**DC-10****SERVICE BULLETIN**

Bulletin 52-38
DC-10 SC 858/1003

DOORS - Cargo - Replace Cargo Door Latch Access Covers.

This page transmits Revision 2 for DC-10 Service Bulletin 52-38 to incorporate the following changes:

TYPICAL PLACARD INSTALLATION
(3 PLACES)

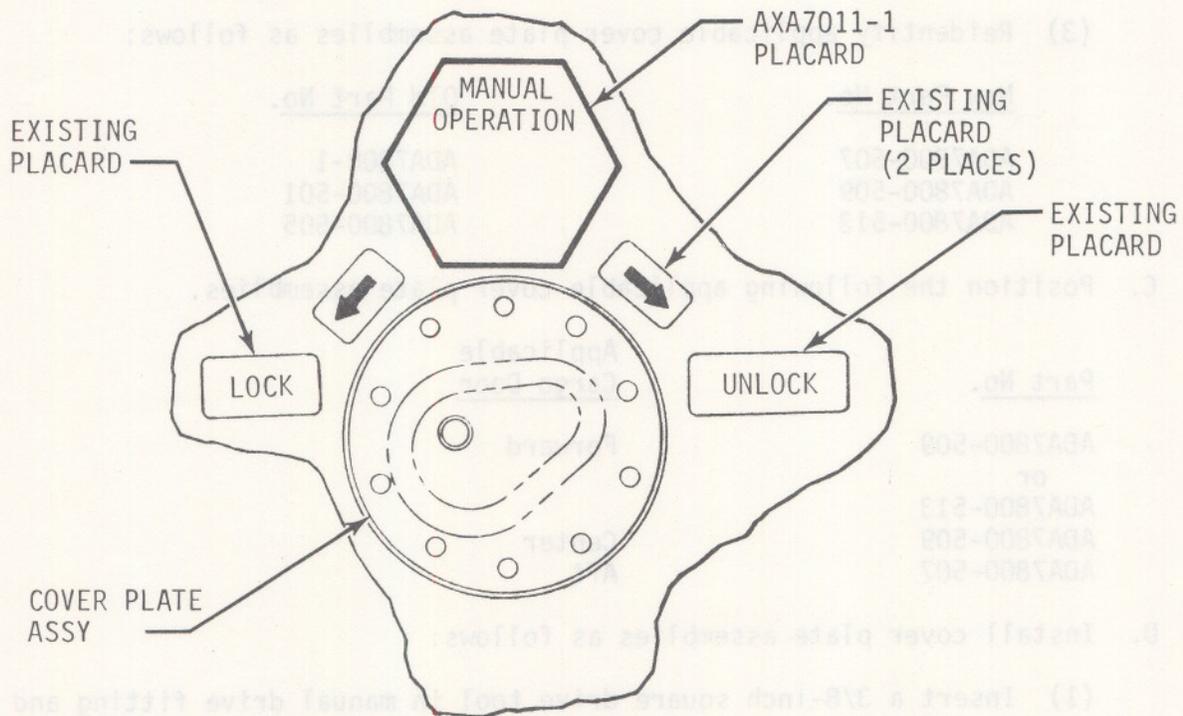
- (2) Drill ten .190/.194-inch diameter holes through cover plate assembly using holes in cargo door as guides.
 - (3) Countersink holes in cover plate assembly 100° x .391-inch diameter.
 - (4) Install cover plate assembly using PR-1422 sealant and retained screws.
- E. Install new AXA7011-1 placard above each cover plate assembly approximately as shown on sketch.
- F. Reidentify applicable cargo door assemblies as follows:
